ABP Reference Number: ABP-314988-22

**RE: LUCAN TO CITY CENTRE CORE BUS CORRIDOR SCHEME
COMPULSORY PURCHASE ORDER 2022**

NTA Observations on the Proposed Scheme CPO Objections

Figure 2.1.10: Reduction in land take at eastern limit of Hermitage Golf Club Lands

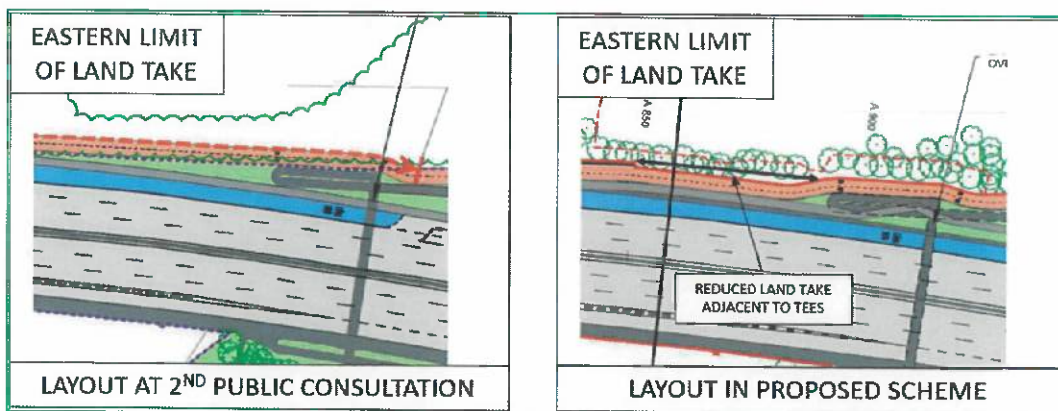
Sections 3.4.1 to 3.4.4 of Chapter 3 of the EIAR discuss various design alternatives considered following each of the three rounds of public consultation. During this period, a number of design alternatives were considered that sought to minimise the impact on the Hermitage Golf Club.

Specifically, following the second round of public consultation and a meeting with representatives of the golf club, the cycle track alignment was amended to minimise the land take at the eastern end of the golf club lands close to two tee boxes. This is evidenced by Figure 2.1.10 which shows an extract from the scheme brochure presented as part of the second round of public consultation, as included in the Appendix to the Public Consultation Report 2018-2022 provided as part of the Supplementary Information provided with the application for the Proposed Scheme.

Figure 2.2.8: Proposed Continuous Bus Lane adjacent to Hermitage Medical Clinic

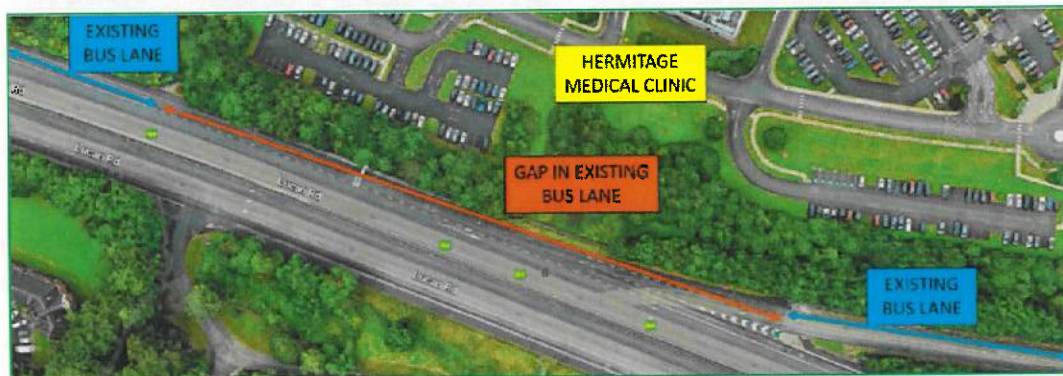
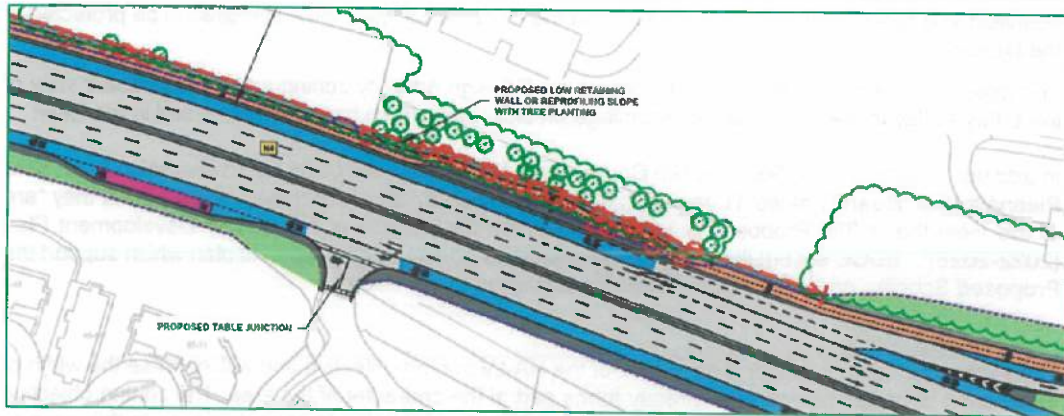
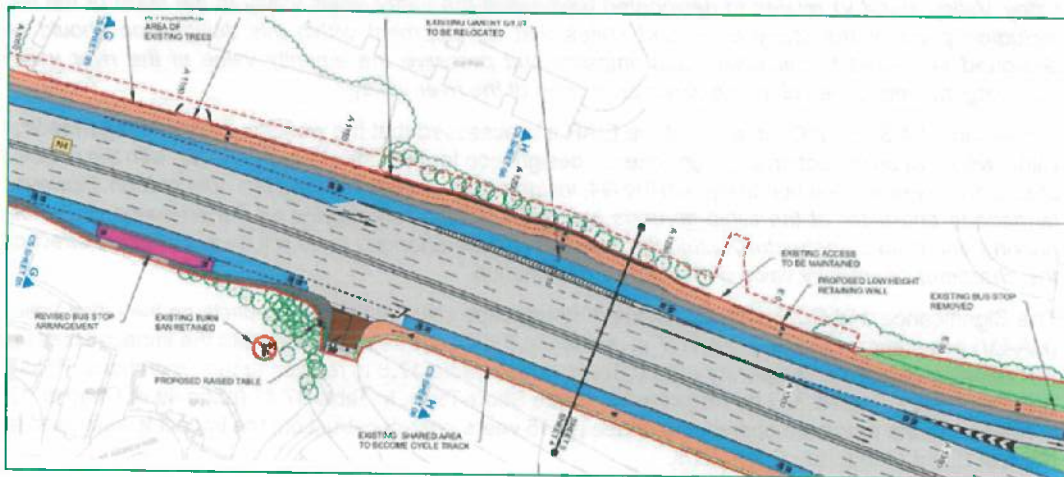
- i) The submission stated that the extents of the lands to be acquired are excessive, and unnecessary, for the implementation of the Proposed Scheme.
- ii) The submission stated that the Proposed Scheme (including the loss of mature trees) may be a Material Contravention of the SDCC Development Plan in respect of the "High Amenity" zoning of the land to be acquired and related policies. It also highlights that there is a significant view identified as to be protected in the Development Plan.

As shown in Figure 2.2.6 below the existing eastbound bus lane at the diverge for Junction 2 of the N4 is discontinuous, with a gap introduced by the parallel diverge lane for general traffic.

Therefore, the design alternative that formed the draft Preferred Route Option was no longer in accordance with the relevant design standard and the design was amended to include a continuous bus lane in the eastbound direction at the diverge to Junction 2 of the N4, as described in section 4.5.1.1 of Chapter 4 of Volume 2 of the EIAR, Proposed Scheme Description.

In summary the continuous bus lane on the eastbound carriageway of the N4 at this location, and the associated permanent and temporary land take, is necessary for the Proposed Scheme to comply with the appropriate design standard.

Figure 2.2.10: Location of Permitted MSCP Relative to Proposed CPO (Image Source: Google)

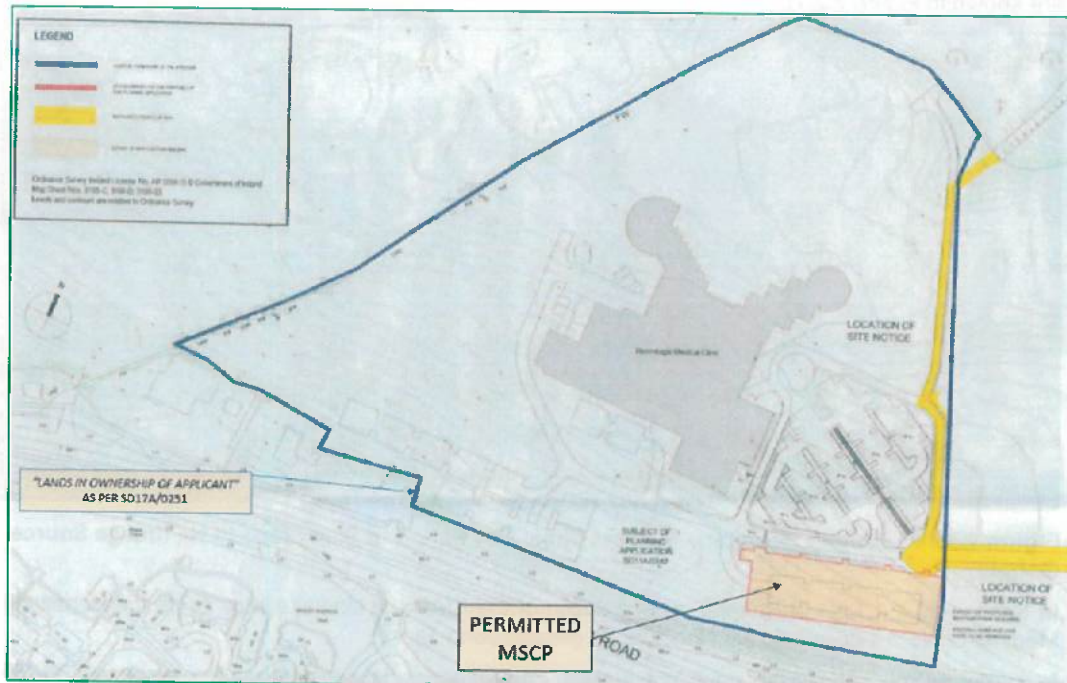
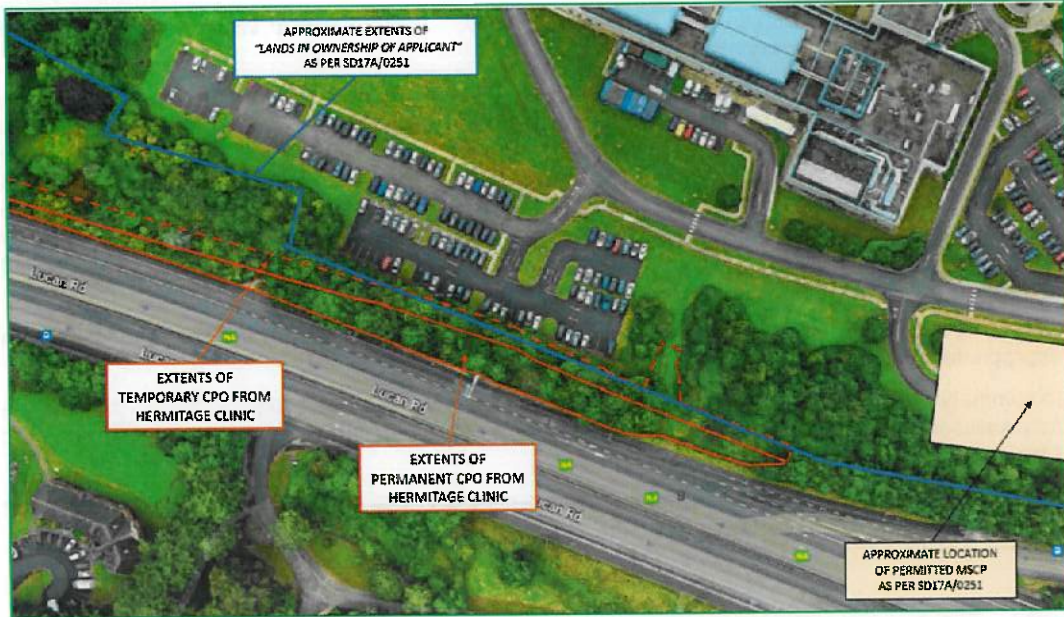
The submission asserts that the "lands immediately adjacent to the proposed CPO are therefore essential to the future expansion of the Hermitage Clinic. If the proposed CPO land take proceeds, it would significantly impact the Hermitage Clinic and the ability to accommodate further expansion of the clinic's facilities in the future."

The above Figures show that the permitted MSCP is not adjacent to the proposed land acquisition included in the CPO.

In addition, the Proposed Scheme adjacent to the Hermitage Medical Clinic as described in Section 2.2.1 earlier; and as shown in Figure 2.2.10 the proposed permanent and temporary land acquisition is limited to the planted side slope supporting the N4 and does not impact the existing car park.

Figure 2.2.12: Extract from Landscape General Arrangement drawings at Hermitage Clinic

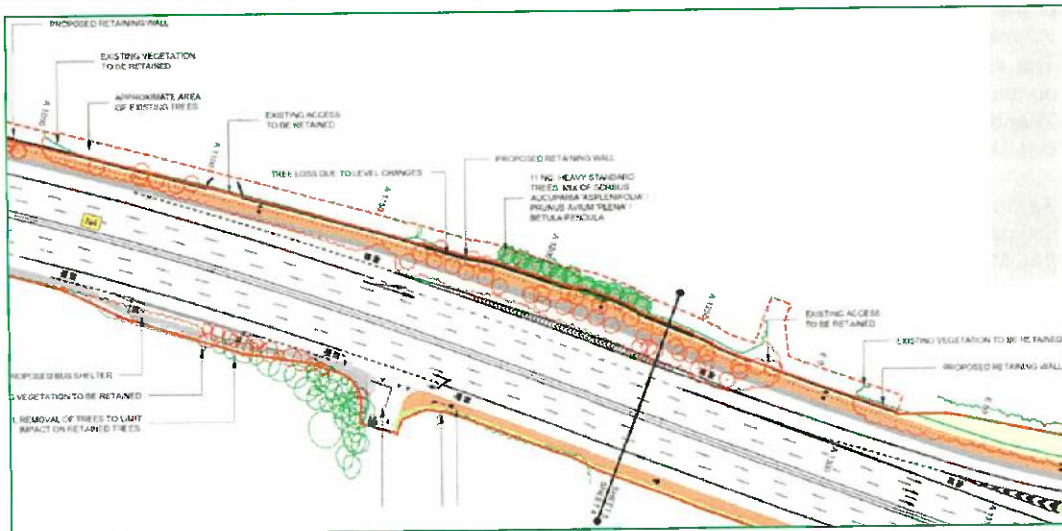
- v) The submission highlighted concerns about the planting works to replace the lost trees and expressed concern in relation to the height of the retaining wall on the Hermitage Clinic side of the proposed boundary.

The Landscaping General Arrangement Drawings in the EIAR, Volume 3, Part 1 of 3, Chapter 4 Proposed Scheme Description include 11 new heavy standard trees (defined as 12-14cm girth, 300-350cm height in accordance with BS3936-1) in the area of temporary land acquisition at the location where existing trees are lost, see extract in Figure 2.2.12.

Figure 2.3.11: Draft Preferred Route Option compared to the Proposed Scheme

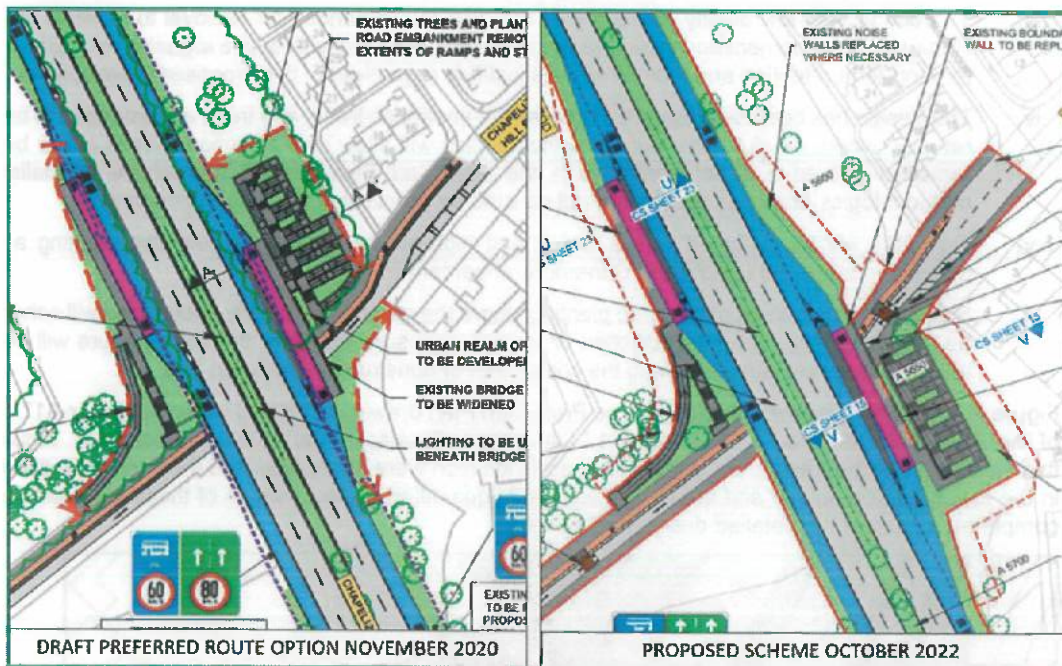
- i) The submission highlighted the scale and length of the proposed ramps and the existing steep slope to them from Chapelizod village. While recognising the benefits of providing access for all the submission questioned the demand from the village for the proposed bus services on the bypass and expressed the view that usage would be low. The submission suggested that a lift should be considered as an alternative solution and also questioned the consideration of alternatives in relation to the previous draft Preferred Route proposal for the ramps to be located on the north side of Chapelizod Hill Road, arguing that a greater number of residential properties are impacted by the Proposed Scheme than would have been impacted by the draft Preferred route proposals.

As described in Section 3.4.4.5 this reduction in height and length had benefits for people using the ramps as well as requiring a reduced area and hence reduced loss of trees and vegetation. The Draft Preferred Route Layout and the Proposed Scheme layout are compared in Figure 2.3.11.

Figure 2.3.13: Typical Cross-section Adjacent to Knockmaree Apartments

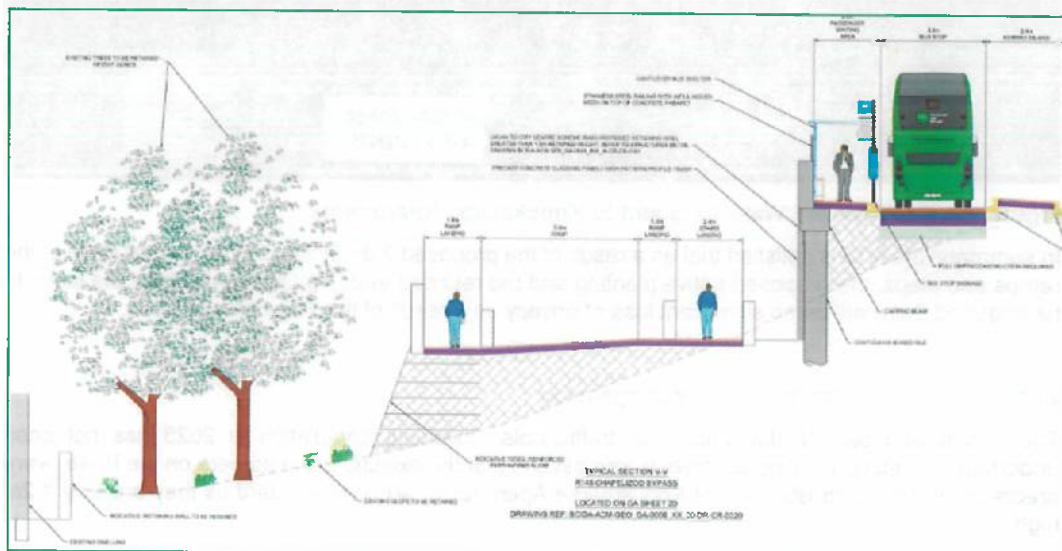
During a consultation meeting with the Knockmaree Management Company and the Knockmaree Residents Association in April 2021 concerns were raised about security and loss of privacy arising from passengers waiting at the bus stop over-looking the apartments. In response to these concerns the design was developed to include a 2.0m high wall to the outer edge of the ramps and steps, as shown in the typical cross-section in the EIAR, Volume 3, Part 1 of 3, Chapter 4 Proposed Scheme Description see Figure 2.3.13.

An additional 0.55m high steel fence with mesh infill will be provided to the top of the concrete parapet to minimise antisocial behaviour and people sitting on the parapet while waiting for an oncoming bus. This combination will allow passive surveillance of the bus stops from the road and steps / ramps to further minimise antisocial behaviour.

Figure 2.3.14: Proposed Walls Adjacent to Knockmaree Apartments

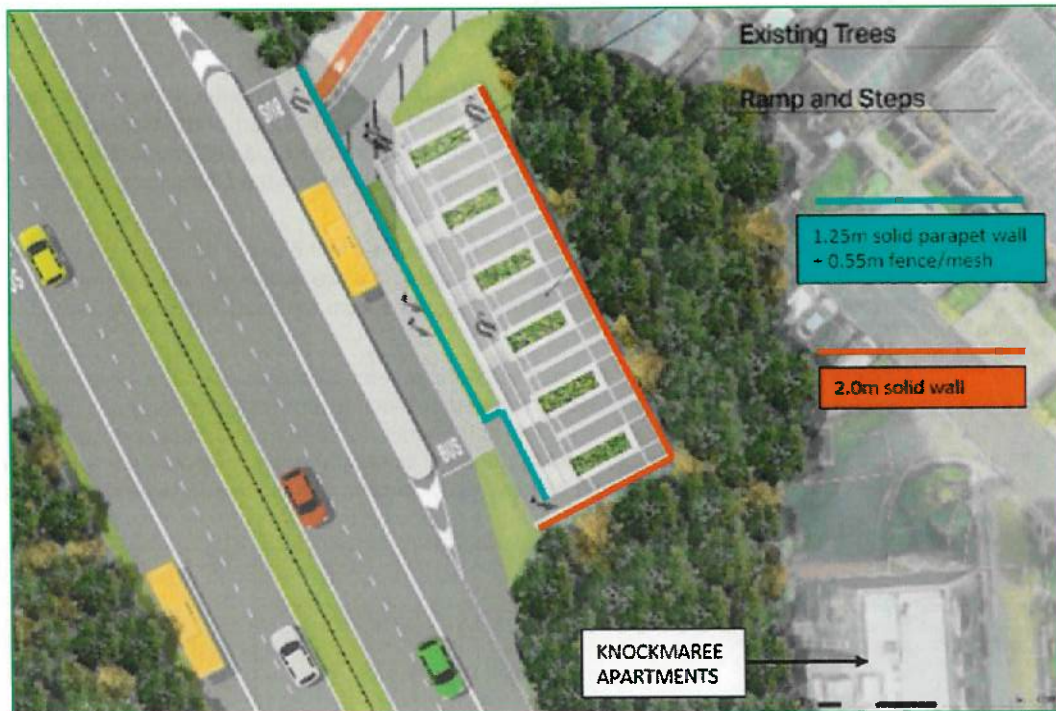
Figure 2.3.14 shows the extents of the both the 1.25m parapet wall and 2.0m high solid wall relative to the Knockmaree Apartments which will maintain privacy and provide security.

In summary, the NTA is satisfied that as a result of the proposed 2.0m high wall to the outer edge of the ramps and steps, the proposed native planting and the retained trees / planting outside of the lands to be acquired there will be no significant loss of privacy as a result of the Proposed Scheme.

Figure 2.3.15: Extract from Fencing and Boundary Treatment Drawings

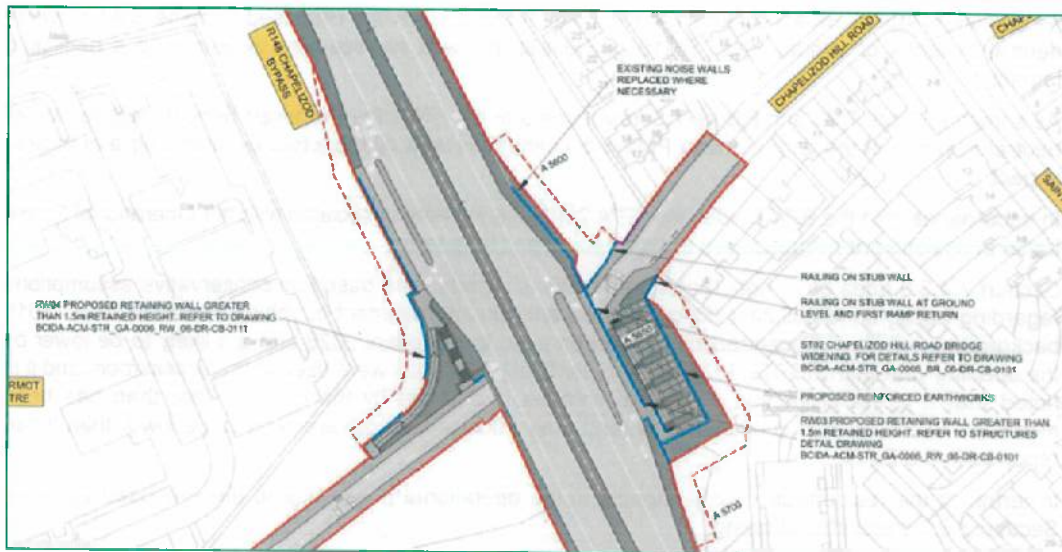
Section 9.4.4.3 of Chapter 9 relates to noise from bus stops and notes that new bus stops are proposed at Chainage A5+560, Chapelizod Bypass east, which have noise sensitive locations in proximity. It also notes that the closest noise sensitive locations to the new bus stop along the Chapelizod Bypass at Chainage A5+560 are residential properties along Chapelizod Hill Road. It goes on to state that: "The new bus stop at this location have been designed to reduce noise impacts through the incorporation of a solid wall along the top of the ramp will be a minimum height of 1.2m. In addition, the existing noise barriers along the Chapelizod Bypass will be retained or replaced in proximity to the new bus stop." The Fencing and Boundary Treatment Drawings in EIAR Volume 3 Chapter 4 Part 1 of 3, see Figure 2.3.15 and the typical cross section in Figure 2.3.13 above confirm this.
